# Supporting Documentation

## Marbury St Michael – Paths

**ST. MICHAEL'S CHURCH, MARBURY - CHURCH PATHS**

# Marbury, St. Michael, lower churchyard access path,

Dec '21 dwg no 1124-14-3  
rev Feb 22

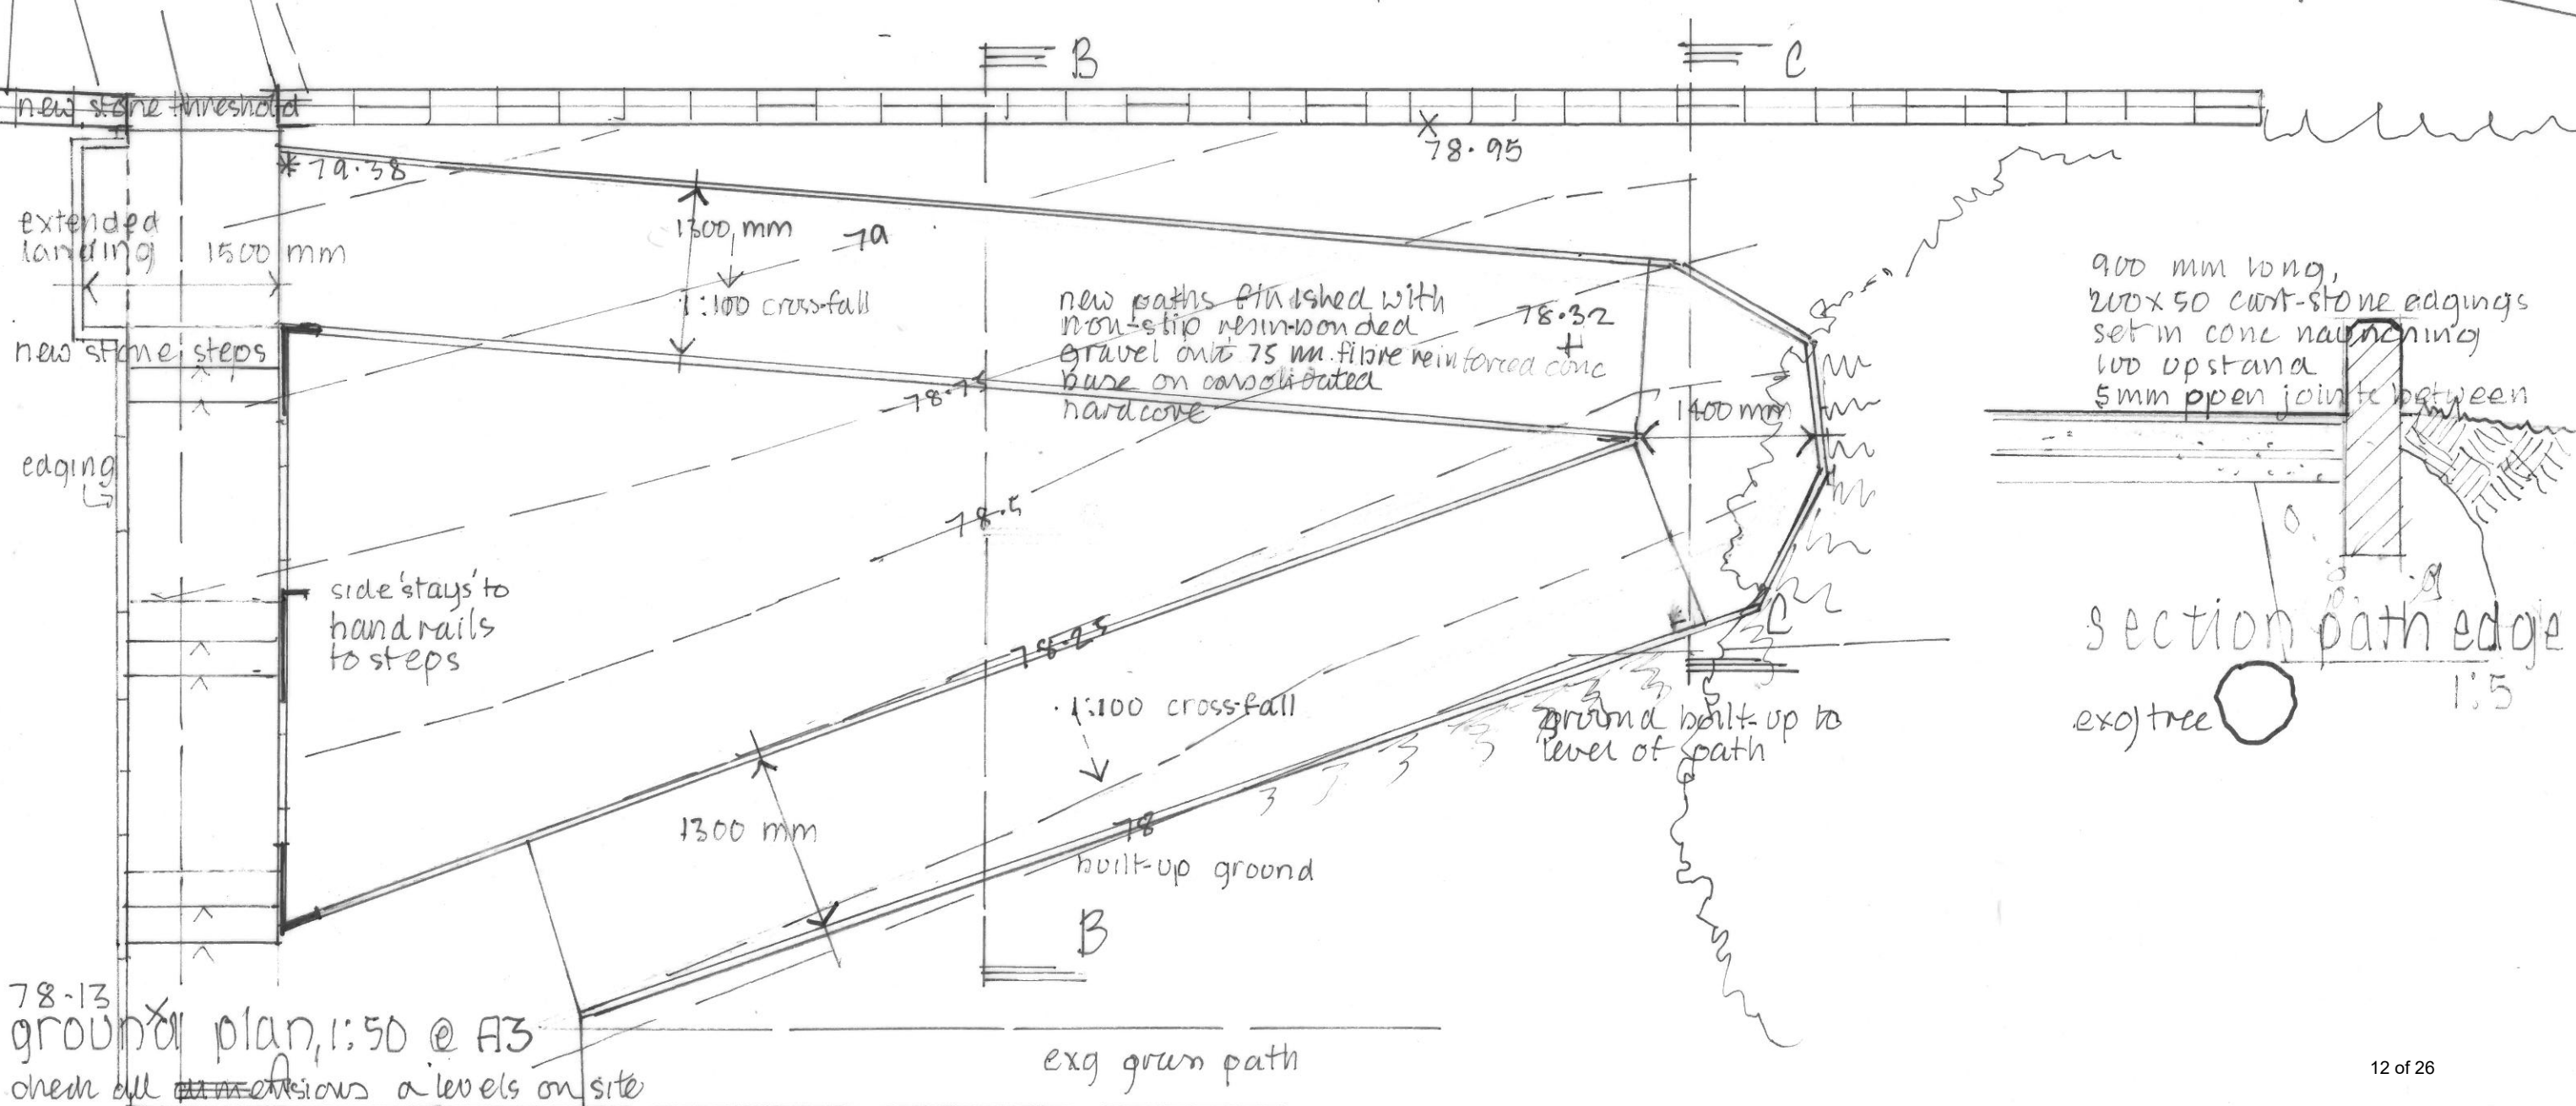
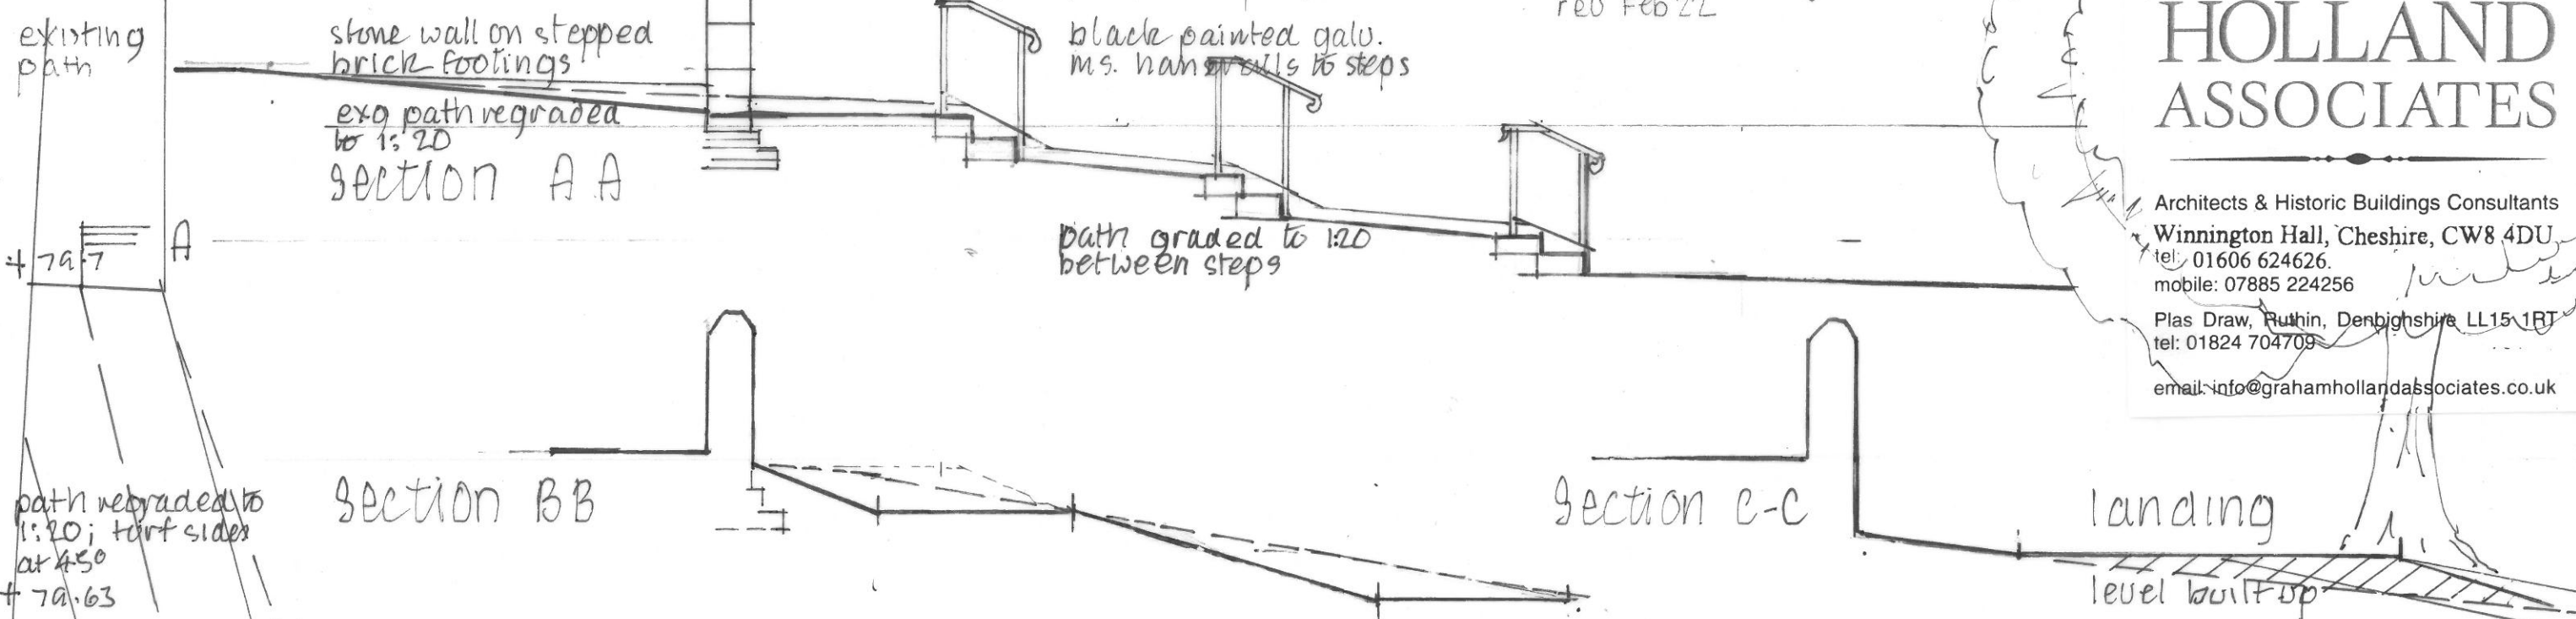
<p><b>24/03/2022</b></p> <p>To: Richard Sheard From: Graham Holland</p>	<p>for clarity, at Knutsford Ch E. objected to tarmac { which was on all the other paths ! } .</p> <p>They agreed to bonded gravel</p>
<p><b>06/06/2022</b></p> <p>To: Richard Sheard, Graham Holland From: Katy Purvis</p>	<p><b>DAC advice</b></p> <p>I'm writing to let you know that at its meeting of 27 May 2022 the DAC considered the formal application to for the new paths and resolved to recommend the scheme, subject to receipt of satisfactory details as advised and the following provisos</p> <ul style="list-style-type: none"> <li>a. The works to be under the direction and subject to the inspection of the Church Architect</li> <li>b. The parish to obtain any necessary planning consent</li> </ul> <p>The parish to provide the following information:</p> <ul style="list-style-type: none"> <li>a. A drawing(s) showing sections along the full length of the ramp to indicate where there are landings</li> <li>b. Dimensions demonstrating that the width of the ramp complies with Building Regulations</li> <li>c.</li> </ul>

<p><b>06/06/2022</b></p> <p>To: Katy Purvis, Richard Sheard From: Graham Holland</p>	<p>Drawings of the full length of the ramp were provided as again attached .</p> <p>Note , the long 'dog-leg ' is a 'path' not a'ramp'</p> <p><a href="#">6) Drawings numbered 1124.14.3 and 1124.14.4 of Graham Holland Associates dated February 2022 (as previously received 23/03/2022)</a></p> <p><a href="#">8) Drawing number 1124.14.2 of Graham Holland Associates dated April 2022</a></p>
<p><b>30/06/2022</b></p>	<p>I am writing to let you know that at its meeting of 24 June 2022 the DAC considered the Church Architect's response to its previous</p>

<p><b>01/07/2022</b></p> <p>To: Caroline Hilton, Richard Sheard From: Graham Holland</p>	<p>My view remains that given the slope of the land the proposal is 'reasonable'.</p> <p>The stepped path complies with the 'Regs'.</p>

Marbury, St. Michael; access path  
to the lower churchyard ramped & stepped path  
February, 2022 dwg<sup>no</sup> 1124.14.4

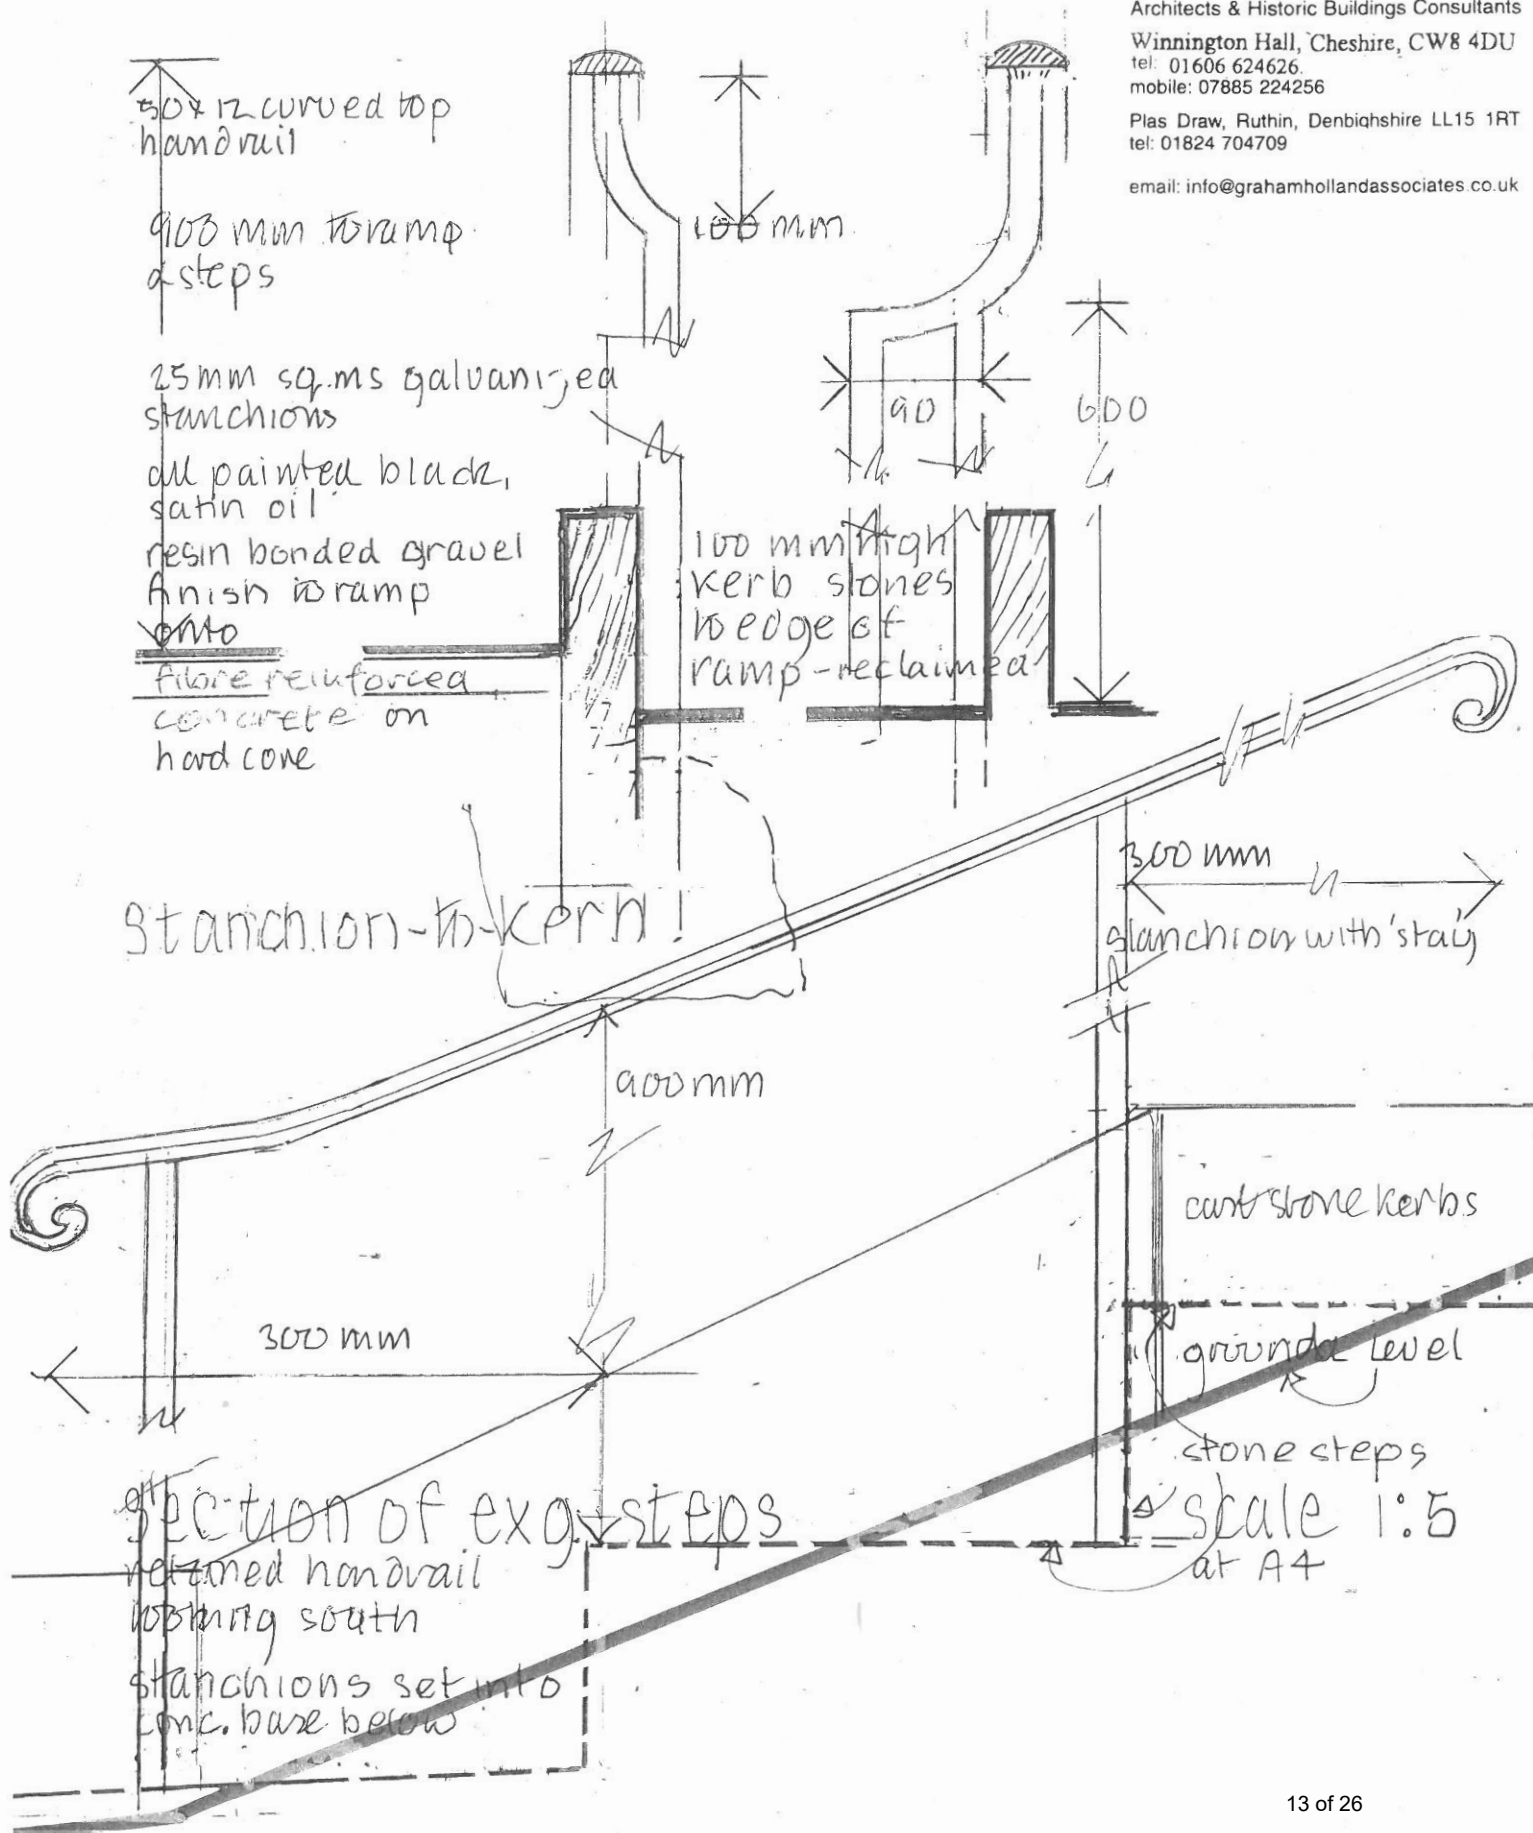
everything you need to know about adaptations and required measurements, and takes in to account the underpinning legislation of the Equality Act 2010.
<b>27/02/2022</b>  To: Richard Sheard From: Graham Holland	Thank you for your emailed letter & comments from Vanessa Layfield the Diocesan Access Officer on the draft proposal drawing. There was no 'camber' intended but a slight cross fall for drainage, now noted. The edges of the ramp will be open jointed – 5mm. grey cast-stone contrasting with the 'gravel finish. Technically the 'new' path is a 'sloping path' at 1:20 not a 'ramp'. The width of the new path scales 1,300mm. now noted on the dwg. I have extended the top landing, by the wall gate to give a little more turning space. You may wish to consider improving the existing path in the old churchyard; loose gravel is difficult for wheeled-chair users; it is a bit narrow, though constricted by grave markers. I trust of help; my next job would be to prepare the specification & schedule. Following this a Faculty & Planning permission would be required for the works. Meanwhile I have detailed the handrails.
